EXPERT WITNESS REPORT

I, Maison Azdari, have been engaged as an independent building expert witness in relation to water ingress and associated building defects affecting Sample Property, Suburb withheld NSW.

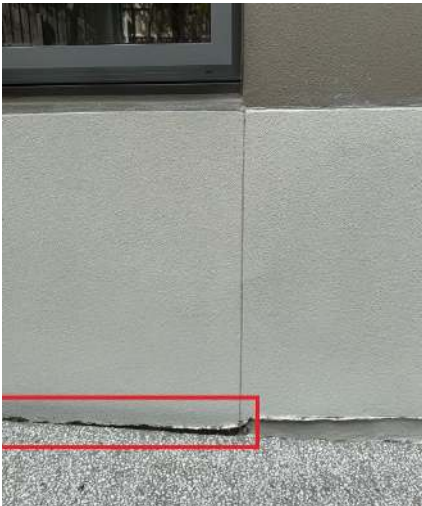
This preparatory step is now concealed by subsequent works. No photographic evidence or inspection records have been provided. I am therefore unable to verify whether the concrete slab was pressure cleaned and prepared in accordance with the regulated design.

Pressure water clean the concrete slab along the building wall to achieve concrete surface clear from any dust, dirt, grease and other impurities.

2.1 (13)

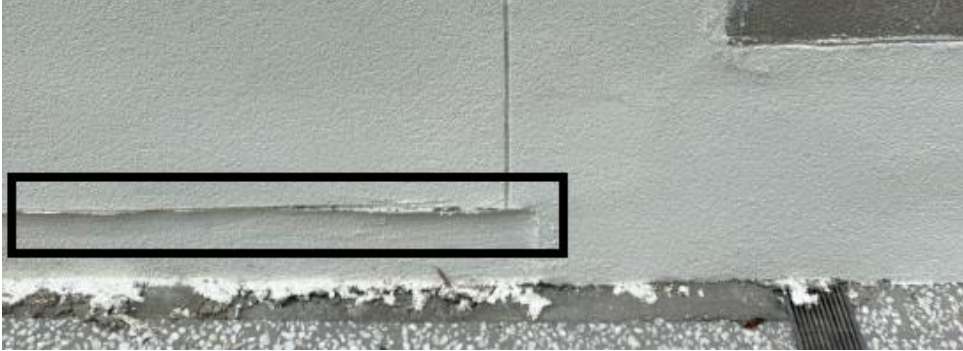
At the time of inspection this joint was fully covered by render. The presence or absence of a backing rod cannot be visually verified and no evidence has been supplied to demonstrate that a backing rod was installed at the correct depth. I am therefore unable to comment on compliance.

Provide a backing rod in the joint between the dwarf brick wall and the Hebel panels minimum 20mm back from the front face of the wall.

2.1 (20) The top surface of the new slab along the external wall of the building is not to be higher than 100mm below the termination point for the waterproofing.

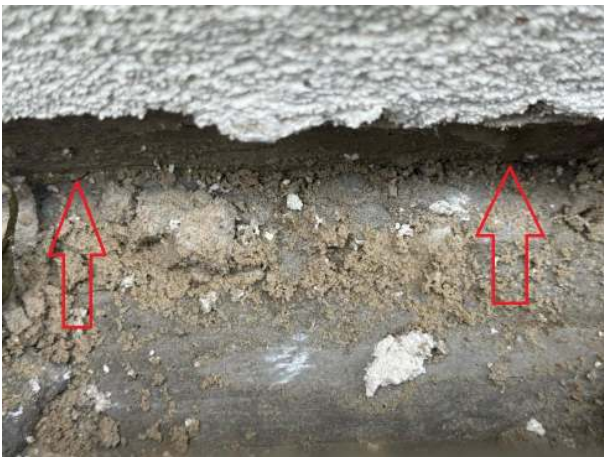
There are sections of the new slab where the finished surface is noticeably closer than 100mm to the proposed waterproofing termination level on the wall. This reduced clearance increases the risk of splash back and moisture ingress into the wall system. In my opinion these areas do not comply with the regulated design and require rectification.

2.1 (22) Provide saw-cut joints within the new slab at 3 metres maximum. Saw cuts to be 5mm wide x 20mm deep and to extend for the full length / width of the slab. Terminate slab reinforcement on both sides of the saw cut. Fill the joints with an approved flexible sealant upon completion.

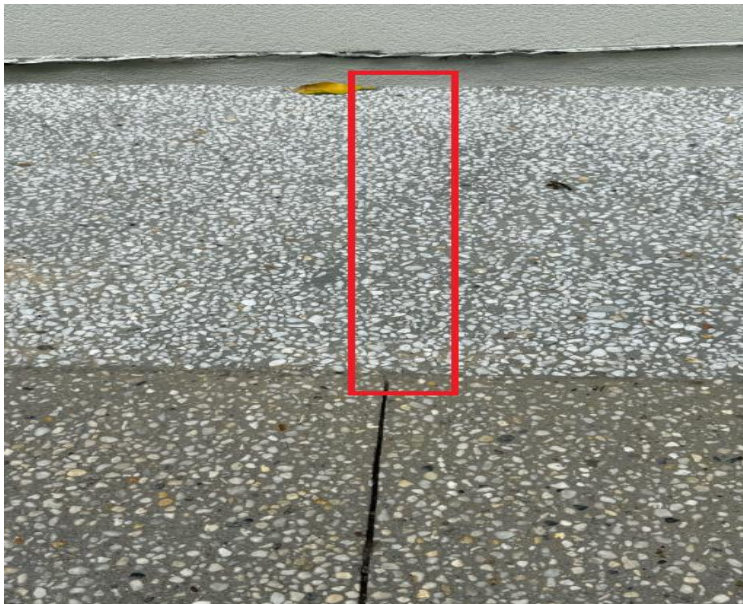
I did not observe any contraction joints or saw cuts within the new slab surface. There is no evidence of saw-cut joints filled with flexible sealant at the specified centres. I am therefore of the opinion that this structural and waterproofing control measure has not been implemented.

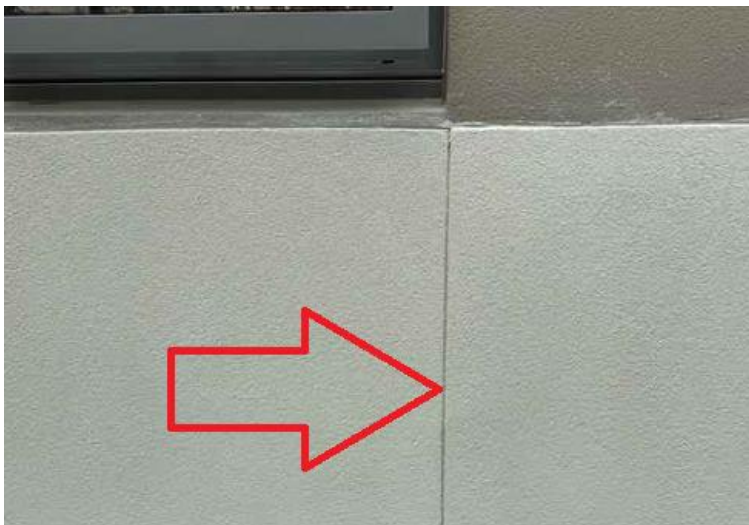
The Hebel wall has been re-rendered and repainted. The finish does NOT matches the surrounding façade in appearance/colour.

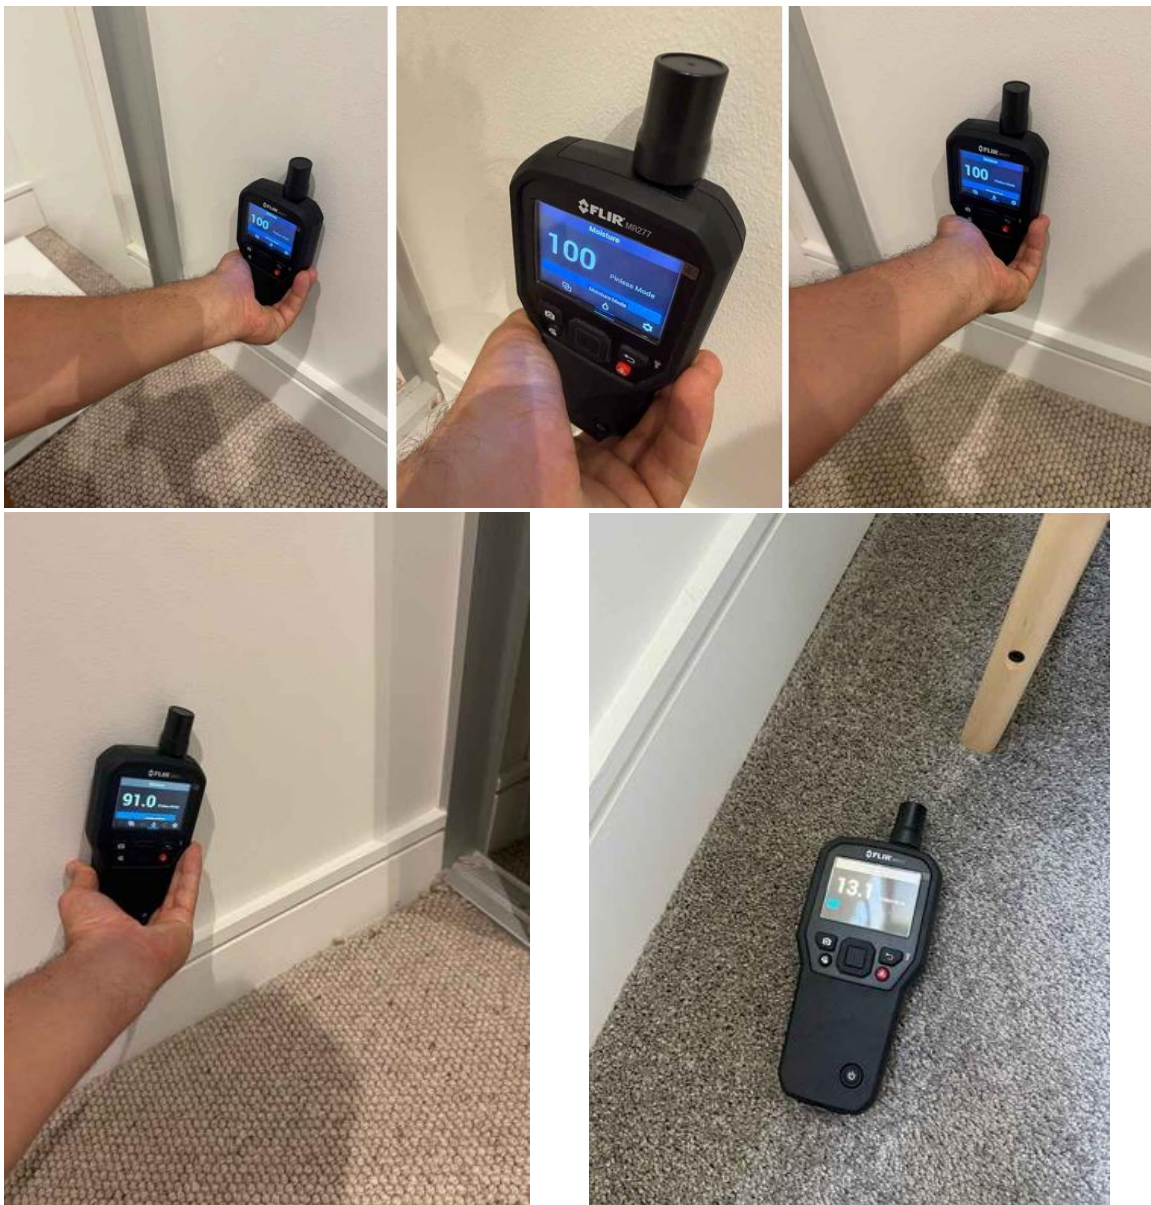
The excavation has been backfilled and the external grade reinstated. I cannot confirm the nature or quality of the fill material used, as no documentation has been provided and the material is not visible. The term "approved fill material" is not defined in the regulated design documentation available to me, so I cannot confirm whether the material used would meet that requirement.
